# **INTEGRATION PROJECT EXPERT PANEL**

## **Closeout Report for Panel Meeting Held May 24 – 26, 2000**

**Prepared by the Integration Project Expert Panel**

**August 21, 2000**

Figure A1 - Simplified sketch of Goodman's Figure 14.

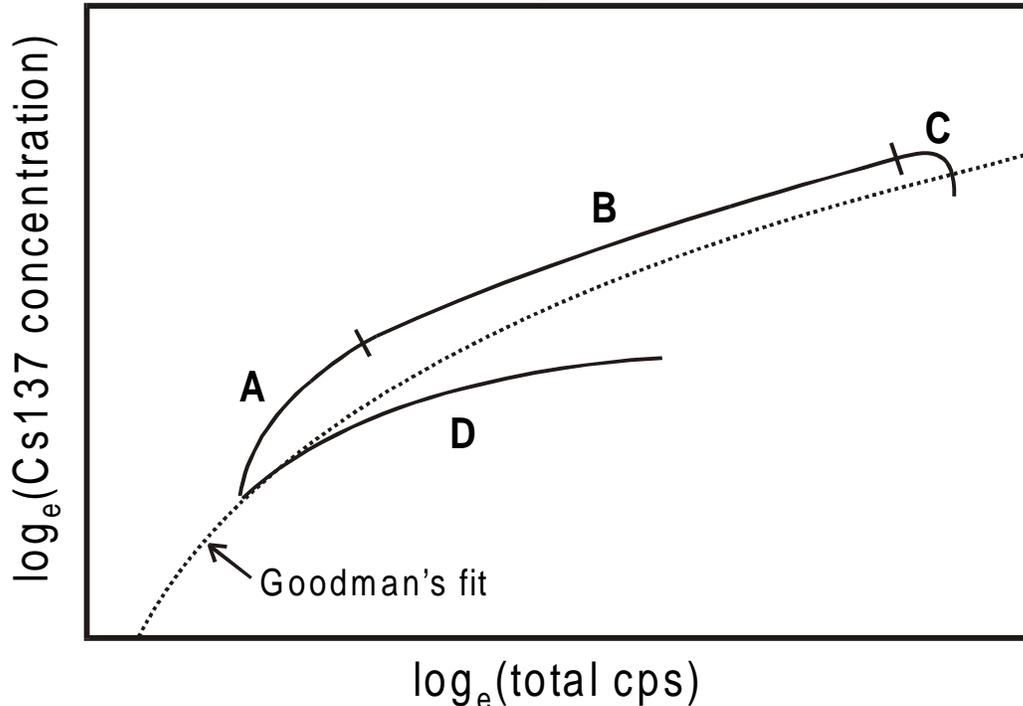
A simplified sketch of Goodman's Figure 14 is shown as Figure A1, below. The data structure in Figure 14 appears to result from at least four distinct phenomena plus a lot of

scatter. Figure A1 is divided into four regions, designated by the letters A – D, based on the phenomena involved; Goodman's best-fit line is represented by the dotted line in Figure A1.

Region A is a low countrate region where gamma rays from natural gamma emitters (and possibly instrumental noise) affect the total counts without adding to the  $^{137}\text{Cs}$  concentration estimate. At very low countrates, the natural signal dominates completely.

Region B is an essentially linear region where estimated  $^{137}\text{Cs}$  concentrations are proportional to total counts with a slope of approximately +1, as expected.

In region D a separate, distinct line is visible, possibly the result of some sort of borehole or detector effect. Fainter "lines" similar to the one designated as region D also appear to be present in Figure 14.

The power curve fitted in Goodman's Figure 14 ignores the data structure, includes data that clearly should not have been included, and misses entirely the linear region of proportionality between estimated  $^{137}\text{Cs}$  concentrations and total counts (region B). Of the four regions shown in Figure A1, only data from region B should have been included in the calibration of  $^{137}\text{Cs}$  concentration versus total counts. In other words, only values that were initially reported as  $^{137}\text{Cs}$  concentrations should have been used in the kriging calculations for
